Access Compliance Report Public Rights-of-Way (Curb Ramps)

Main Street: S_WOODLAND_ST Cross Street: LARKSTONE_DR Location: SW

ADA ID: RPAT211005122308 Ramp Type: Type 1 - Perpendicular Diagonal Initial Pass/Fail: Fail Overall Compliance: No Severity Score: 2

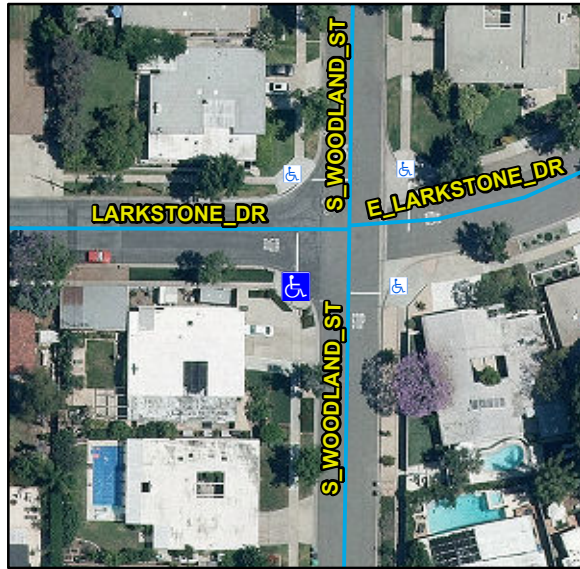
Compliance	Description	Data	Compliance	Description	Data
N/A	Ramp Length (in)	123	N/A	Flare Type LT	
Yes	Ramp Width (in)	55			N/A
Yes	Ramp Run Slope (%)	7.5	N/A	Flare Slope LT (%)	N/A
No	Ramp Cross Slope (%)	4.9	N/A	Flare Traversable LT	N/A
N/A	Landing Present	N/A	N/A	Flare Type RT	
N/A	Landing Length (in)	N/A			N/A
N/A	Landing Width (in)	N/A	N/A	Flare Slope RT (%)	N/A
N/A	Landing Run Slope (%)	N/A	N/A	Flare Traversable RT	N/A
N/A	Landing Cross Slope (%)	N/A	N/A	DWS Provided	N/A
N/A	Landing Movement Obstructed?	N/A	N/A	DWS Contrast	N/A
	Landing Movement Type	N/A	N/A	DWS Length (in)	N/A
N/A	Landing Shared	N/A	N/A	DWS Full Width	N/A
N/A	Clear Space	Yes	N/A	DWS Offset Left (in)	N/A
N/A	Clear Space To Crosswalk (in)	N/A	N/A	DWS Offset Right (in)	N/A
N/A	Marked Crosswalk 1	No	N/A	Marked Crosswalk 2	No
	Crossing 1 Direction	E		Crossing 2 Direction	N
	Marked Crosswalk 1 Width (in)	N/A		Marked Crosswalk 2 Width (in)	N/A

N/A	Ramp Inside Crosswalk 1	N/A	Yes	Ramp Inside Crosswalk 2	N/A
	Crossing 1 Slope (%)	0.2		Crossing 2 Slope (%)	5
	Crossing 1 Cross Slope (%)	4		Crossing 2 Cross Slope (%)	1.1
N/A	Gutter Ponding	N/A	No	Curb Slope	12.3
Yes	Gutter Lip Height (in)	0		Road Run Slope (%)	3
N/A	Gutter Run Slope (%)	N/A		Road Cross Slope (%)	5.9
N/A	Gutter Cross Slope (%)	N/A			
Yes	Overall Surface Condition: Acceptable		Yes	Perp Joint Present	Yes
	Cross Gutter Present?	No		Spandrel Present?	No
	Replace Cross Gutter?	N/A		Replace Spandrel?	N/A

Possible Solutions:

Remove & Replace Curb Ramp With Two New Directional Ramps or Equivalent.

R304.2.2, R304.5.3, STD 1115
